Title: 702/720 East Washington Avenue Mixed-Used Development (Working Name)

Re: Letter of Intent – Façade Design Progression
Project: 702/720 East Washington Mixed-Use Development (Working Name)
JLA Architects Project #W22-0106

The items listed below and outlined on the included elevations are design progressions the team has made for the new 720 Mixed Use Building. This package outlines the changes between the previous approvals and the proposed plans.

A200

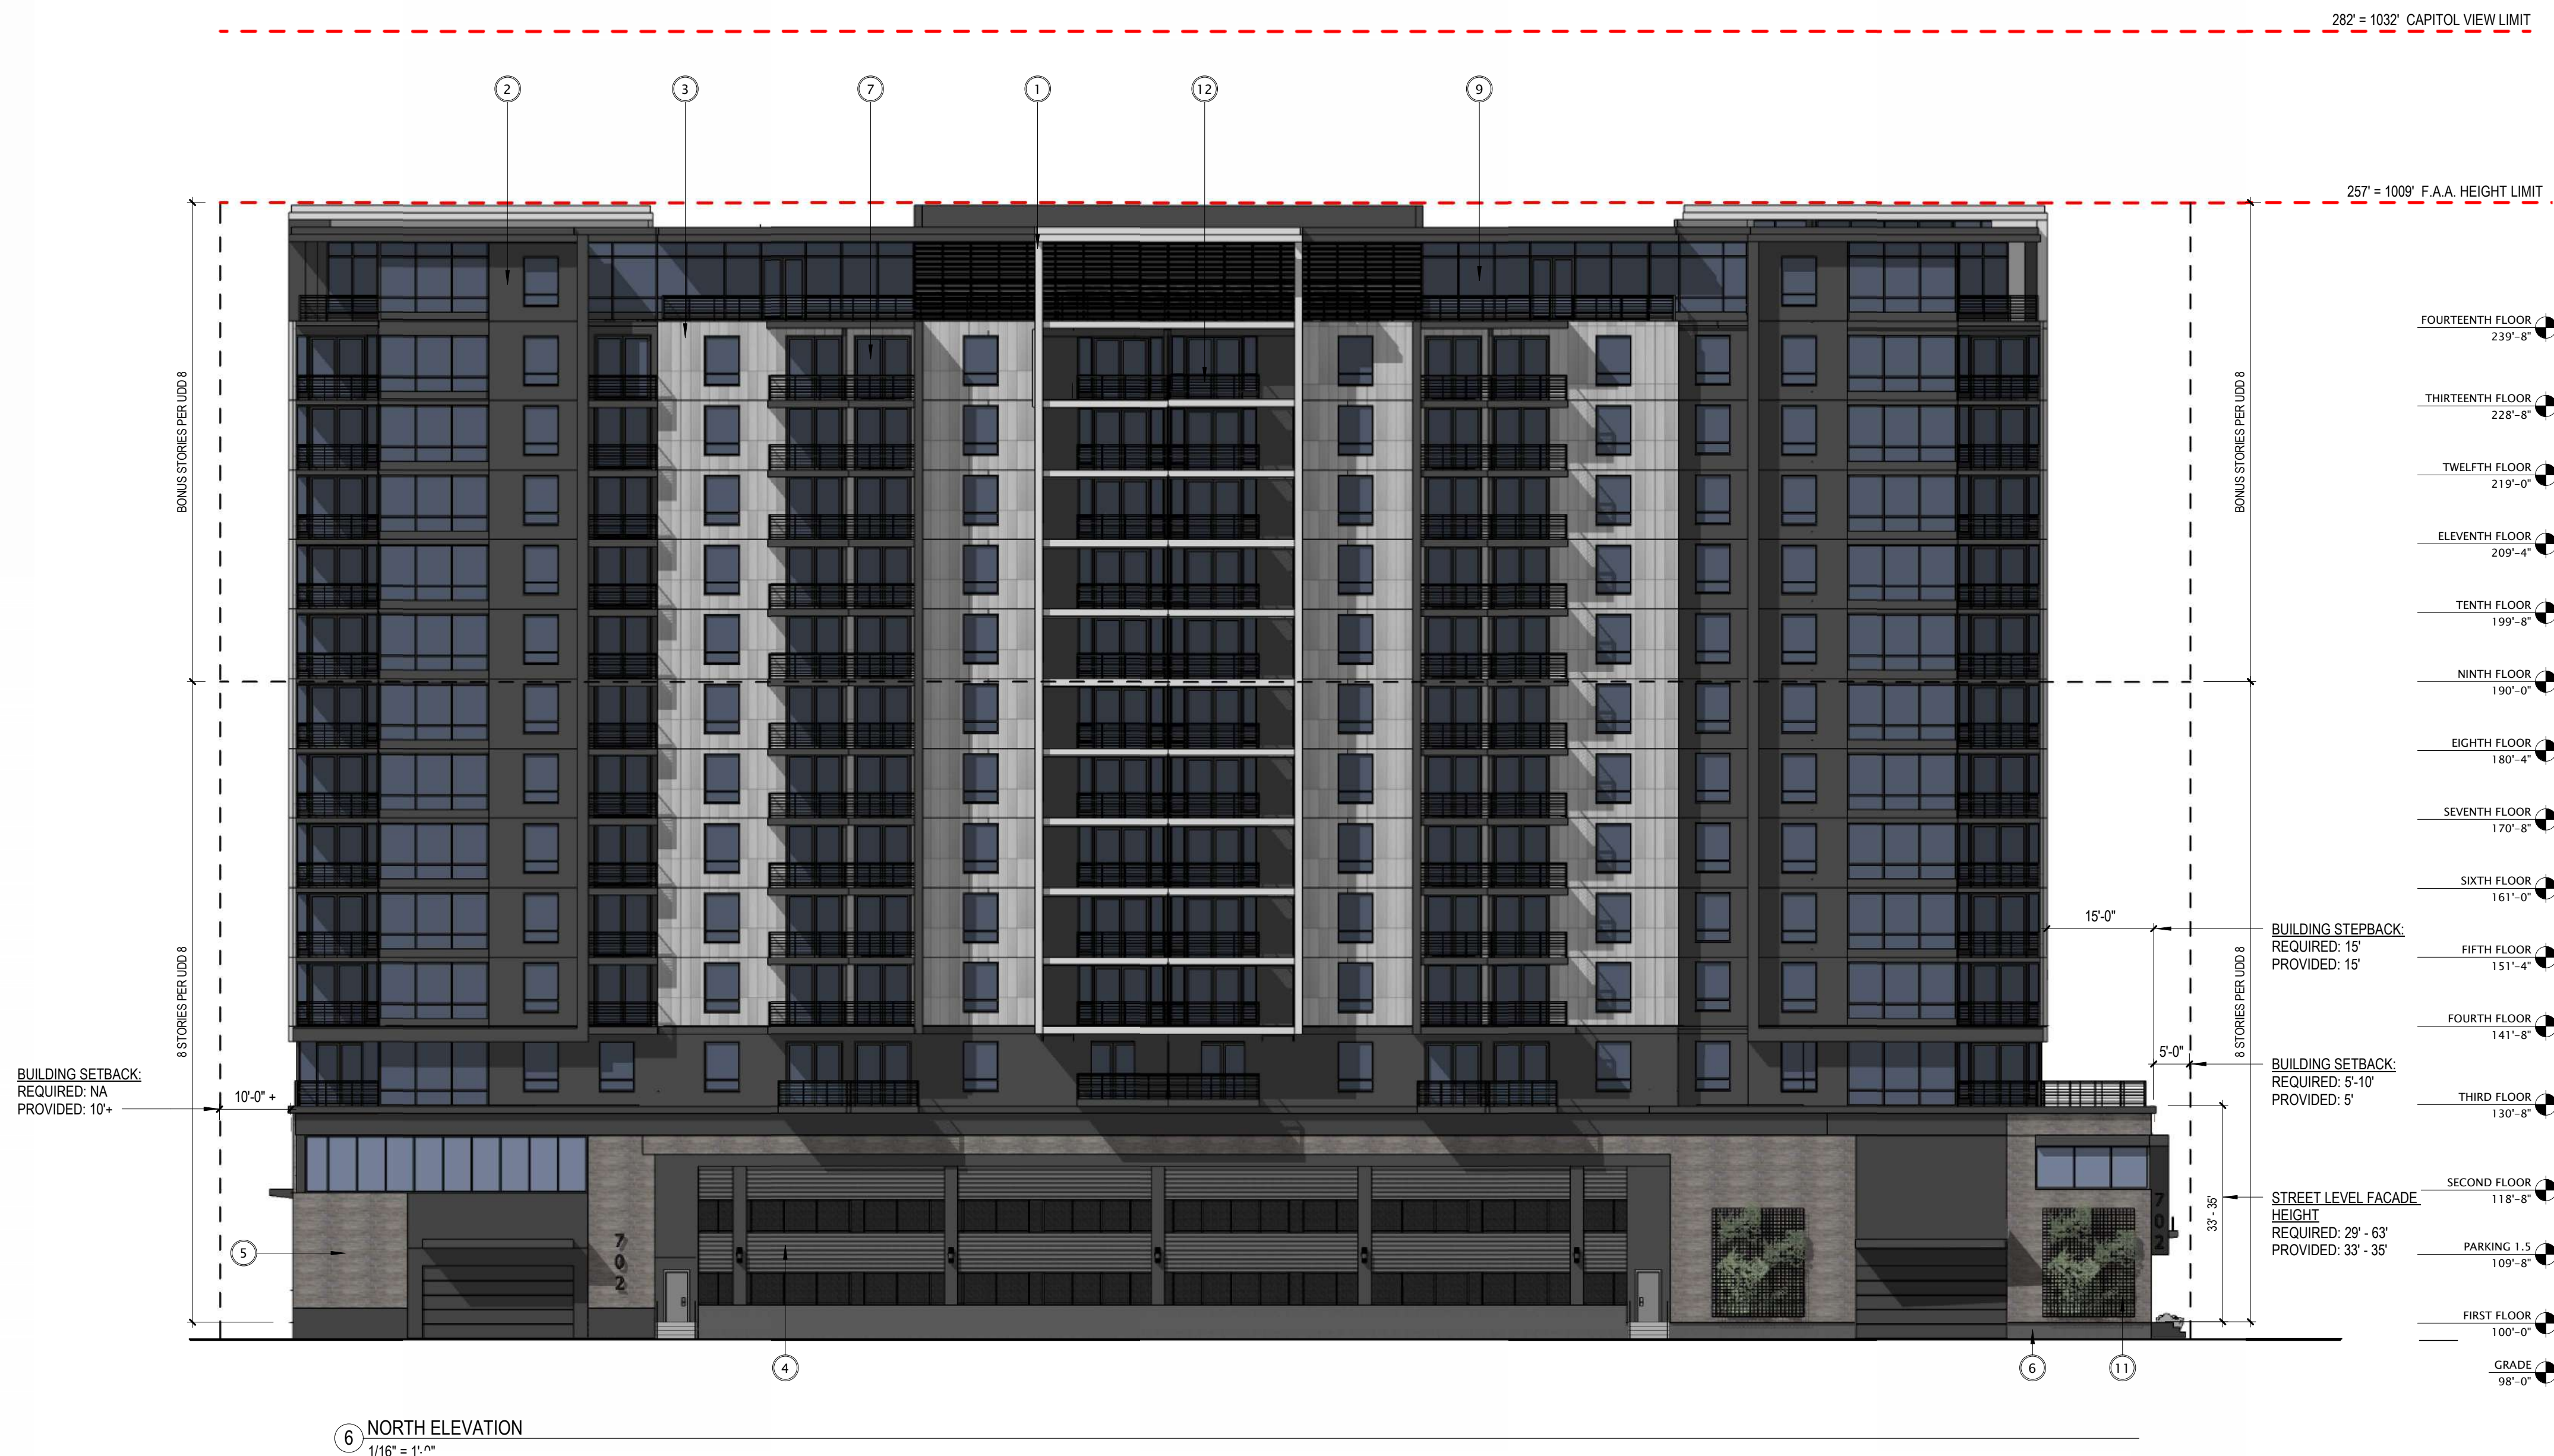
1. Changed to Centria or Muza panel instead of Metal Panel 3
 - a. We are proposing a change from flush metal panels to either Centria or Muza panel systems. This adjustment preserves the integrity of the building's base—primarily composed of masonry brick and large glazing expanses—while enhancing the vertical expression as the structure rises. Both Centria and Muza panels are being considered to achieve this effect, contributing dynamic interaction with light and offering a range of profiles that introduce texture and a rich color palette to the façade.

2. Adjusted many window sizes and removed some windows
 - a. The originally designed building had too many windows to pass the energy code. We needed to add more insulated walls.

3. Changed patio doors from sliders to swinging
 - a. The owner requested this change to help reduce costs.
4. Added lighting to match Photometrics
 - a. The elevations now show exterior lighting locations.

5. Changed to picket rails instead of horizontal rails at balconies
 - a. The owner requested this change to help reduce costs.
6. Changed bottom panel of window walls to be insulated metal panel with an insulated knee wall behind –

- a. The originally designed building had too many windows to pass the energy code. We needed to add more insulated walls. We kept the look of the windows and added an insulated metal panel to the lower portion. This also allows a place to run electrical conduit within the units

7. Roof height changed at a few locations
 - a. These were adjusted as the design progressed due to the FAA height limit and roof penetration heights.
8. Changed some glass to be fritted at parking locations

- a. This helps reduce visibility of cars parked at these windows.
9. Reduced glazing on the 14th floor north elevation
 - a. The originally designed building had too many windows to pass the energy code. We needed to add more insulated walls.

11. Updated locations of green space wall system to match floor plan and landscape plan updates
 - a. As the design progressed, area wells were added and landscaping moved which moved these green wall systems.

12. Added ramp for deliveries on North Elevation
 - a. A delivery drop off area was added to the north side of the building, which needed a ramp to get to the finished floor elevation.

13. Moved meter locations
 - a. As the design progressed, the meters needed to move.
14. Removed divider walls at balconies on the north elevation –
 - a. As the design progressed, we realized that the views for the residents would be limited if these divider walls were here.

16. Removed one "column" of stacked windows on the north elevation –
 - a. These were removed due to floor plan changes and reducing windows to pass energy requirements.
